ROCHESTER GAS AND ELECTRIC CORPORATION
GINNA STATION ORGANIZATION

Attachment B

Figure 6.2-2

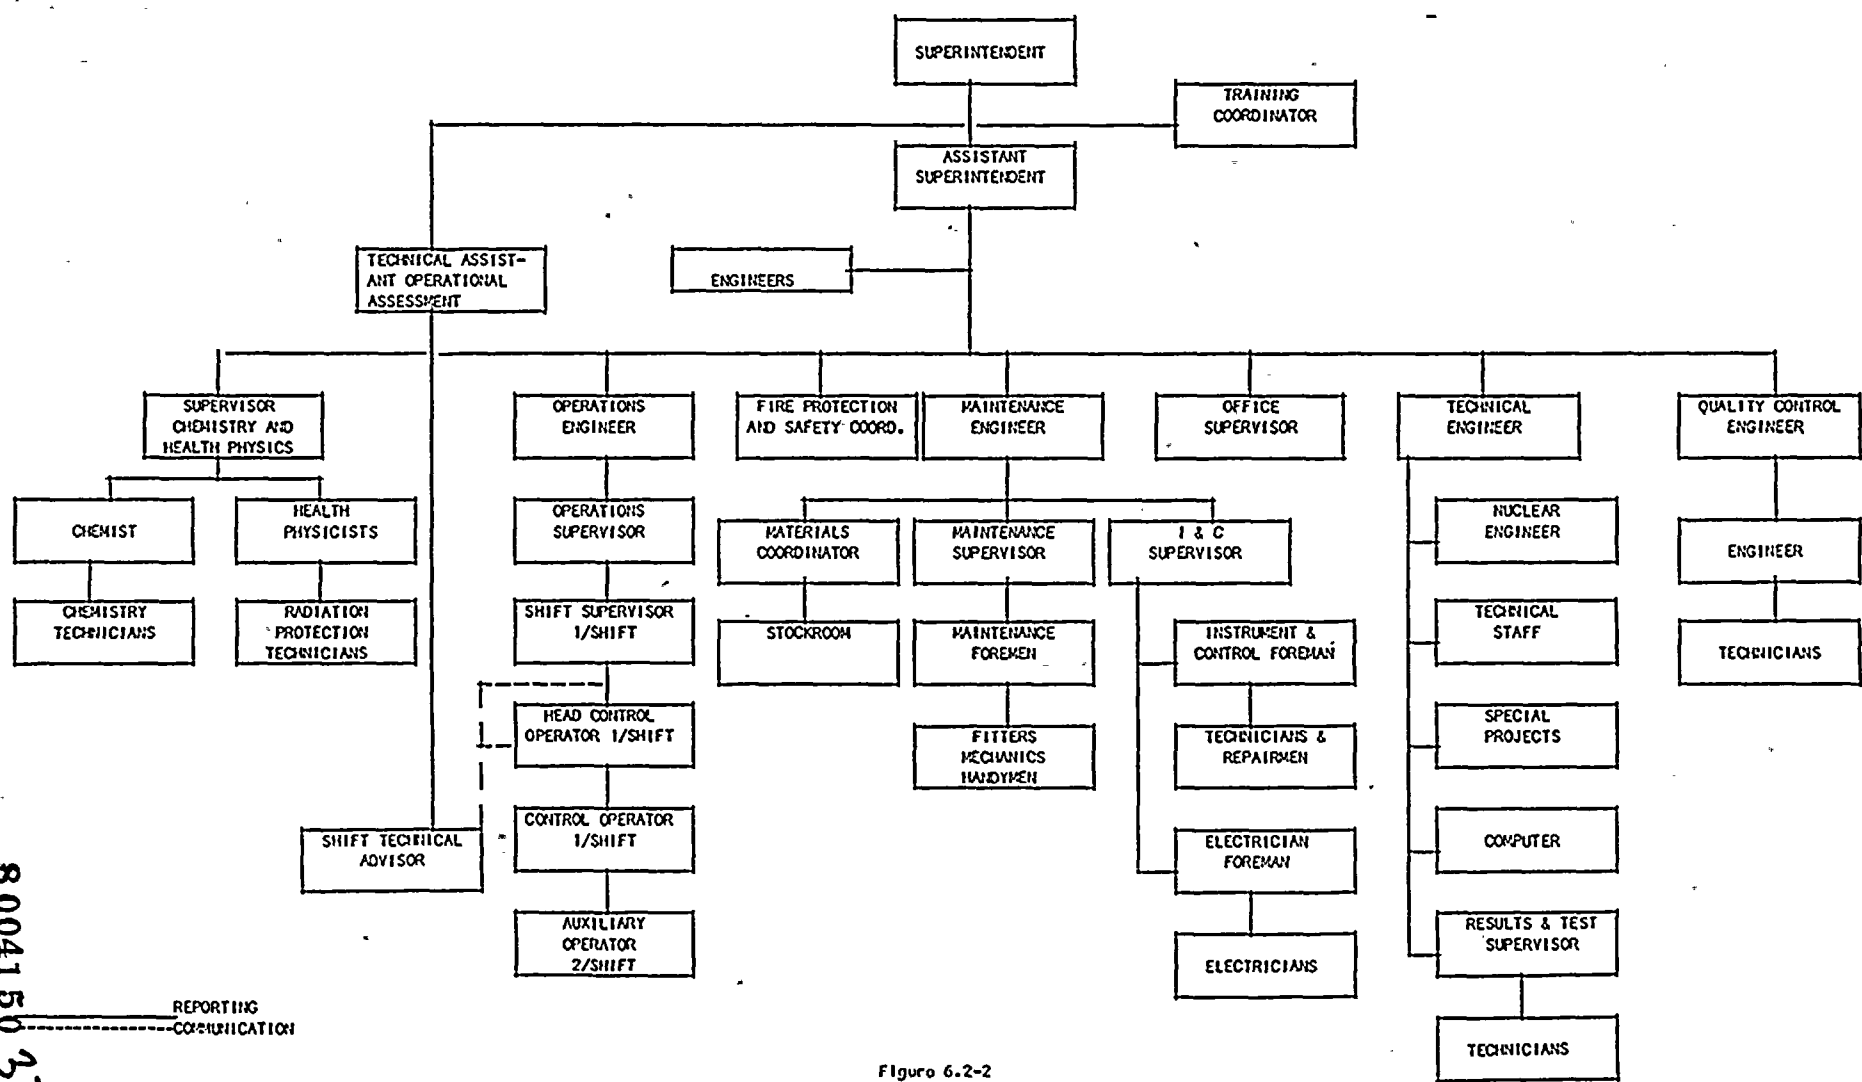
The management organization chart, Figure 6.2-1, has been revised to reflect the position of Shift Technical Advisor. The Ginna Station organization chart reflects the Shift Technical Advisors, the Technical Assistant for Operational Assessment Engineer, minor changes in responsibility under the Maintenance Engineer, the Office Supervisor, and the Technical Engineer.

The Shift Technical Advisor and the Operational Assessment Engineer as being added to reflect implementation of TMI Short Term Lessons Learned. Changes under the Maintenance Engineer reflect the addition of a material coordinator and redistribution of responsibilities. The Office Supervisor is added due to his supervision of Ginna Central Records. Additional details concerning the Technical Engineer's responsibilities are provided.
